MIL-R-83536/16A
AMENDMENT 3
30 September 1996
SUPERSEDING
AMENDMENT 2
15 December 1995

RELAYS, ELECTROMAGNETIC, ESTABLISHED RELIABILITY, 4PDT,
LOW LEVEL TO 10 AMPERES, PERMANENT MAGNET DRIVE, HERMETICALLY SEALED,
ALL WELDED, TRANSIENT SUPPRESSED DC COIL

This amendment forms a part of MIL-R-83536/16A, dated 13 May 1994, and is approved for use by all Departments and Agencies of the Department of Defense.

SOCKET PIN TERMINAL

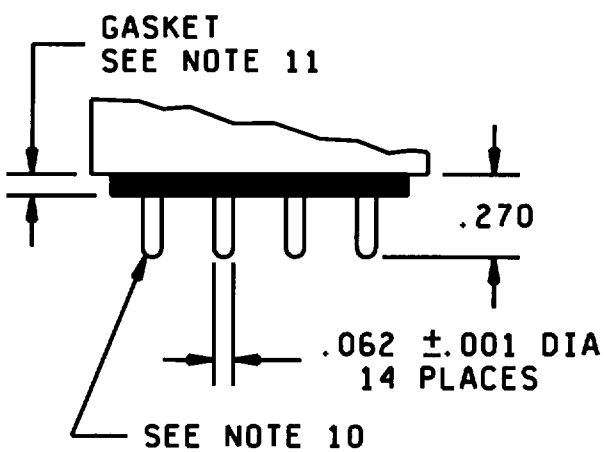
FIGURE 1, socket pin terminal diagram, delete and substitute:

CIRCUIT DIAGRAM (TRACK MOUNT)
(OPTIONAL INTERNAL
DIODE CONFIGURATION)

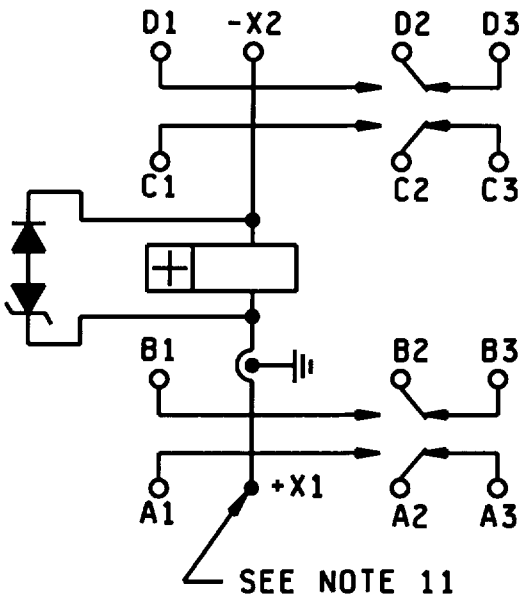
FIGURE 2, add the following new circuit diagram:
